Access Compliance Report

Public Rights-of-Way

(Curb Ramps)

Intersection ID: 10024493	Main Street: CROWNPOINT_EXECUTIVE_DR	Cross Street: N/A	Location: NE
ADA ID: A78286578831	Ramp Type: PerpDiag	Initial Pass/Fail: Fail	Overall Compliance: No
Severity Score: 8.75			
Codes/Mitigation Info/Possible Solution		Field Measurements/Component Compliance

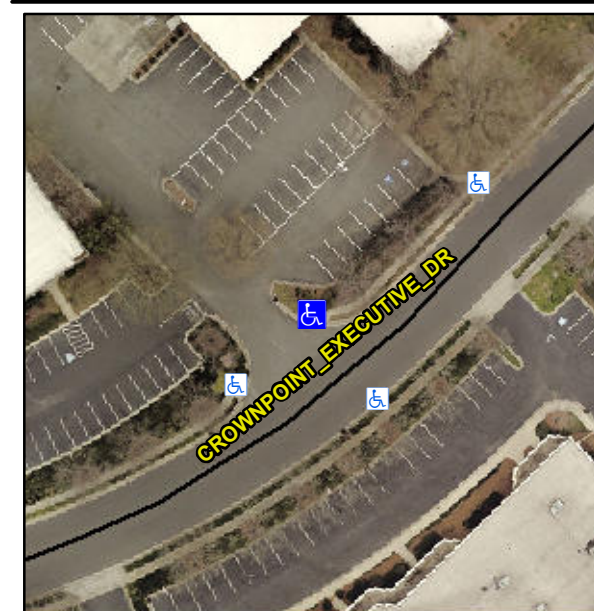
Not Found, R304.5.1

Compliance	Description	Data	Compliance	Description	Data
N/A	Ramp Length (in)	82.0	Yes	Ramp Slope (%)	6.9
No	Ramp Width (in)	43.0	Yes	Ramp XSlope (%)	2.0
N/A	Flare Type LT	N/A	N/A	Flare Type RT	N/A
N/A	Flare Slope LT (%)	N/A	N/A	Flare Slope RT (%)	N/A
N/A	Flare Traversable LT?	N/A	N/A	Flare Traversable RT?	N/A
N/A	Landing Length (in)	N/A	N/A	DWS Provided?	N/A
N/A	Landing Width (in)	N/A	N/A	DWS Contrast?	N/A
N/A	Landing Slope (%)	N/A	N/A	DWS Length (in)	N/A
N/A	Landing X Slope (%)	N/A	N/A	DWS Full Width?	N/A
N/A	Landing Curb? (Y/N)	N/A	N/A	DWS Offset (in)	N/A
N/A	Shared Landing?	N/A			
N/A	Gutter Ponding?	N/A	N/A	Gutter Slope (%)	N/A
N/A	Gutter Lip Ht (in)	N/A	N/A	Gutter X Slope (%)	N/A
N/A	Painted X Walk1?	No	N/A	Painted X Walk2?	No
	X Walk 1 Direction	To SW		X Walk 2 Direction	To SE
N/A	X Walk 1 Width (in)	N/A	N/A	X Walk 2 Width (in)	N/A
	X Walk 1 Slope (%)	4.9		X Walk 2 Slope (%)	2.0
	X Walk 1 X Slope (%)	3.9		X Walk 2 X Slope (%)	4.4

N/A	Ramp inside XWalk1?	N/A	N/A	Ramp inside XWalk2?	N/A
	Road Slope (%)	4.9	N/A	Clear Space?	N/A
	Road X Slope (%)	3.8	N/A	Clear Space to XWalk (in)	N/A
N/A	Any Obstructions?	N/A	N/A	Storm Grate/Utility Hazard?	N/A
	Obstruction Type			Storm Grate/Utility Type	
		N/A			N/A
			Yes	Surface Condition? (G/P)	Good

Remove & Replace Curb Ramp With Two New Directional Ramps or Equivalent.
